**FINAL DRAINAGE REPORT ADDENDUM #1
FOR
PLATTE SELF STORAGE
COLORADO SPRINGS, COLORADO**

OCTOBER 2025

TNE Job No. 2419.00
County Job No. PPR2418

V10_Final Drainage Report.pdf Markup Summary

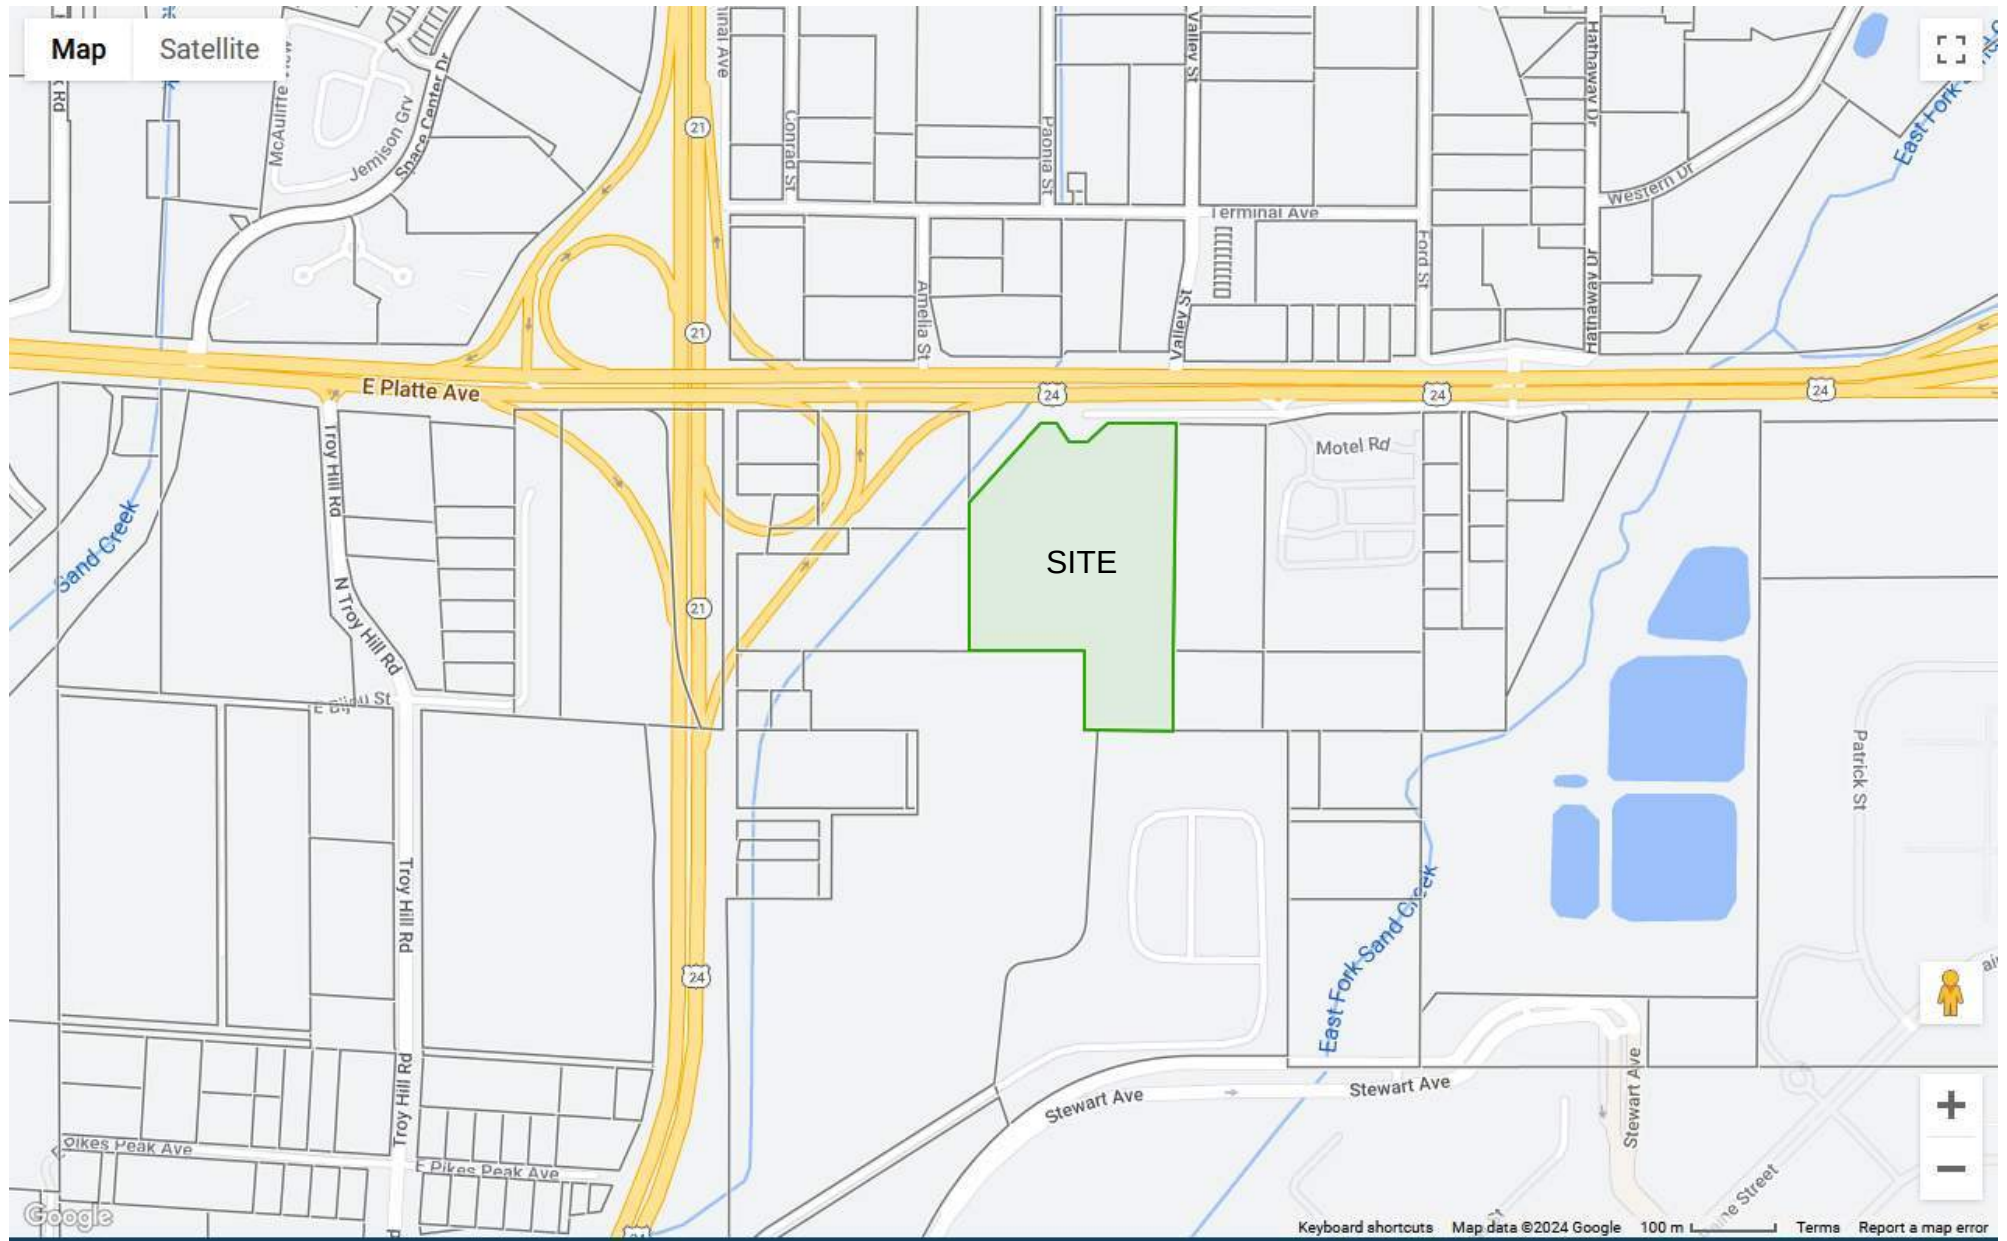
Unresolved:

Include a statement regarding the pond: changes, minor changes, no changes. Works exactly the same or have there been minor changes to outfall/release data?

Unresolved:

Any changes to estimate?
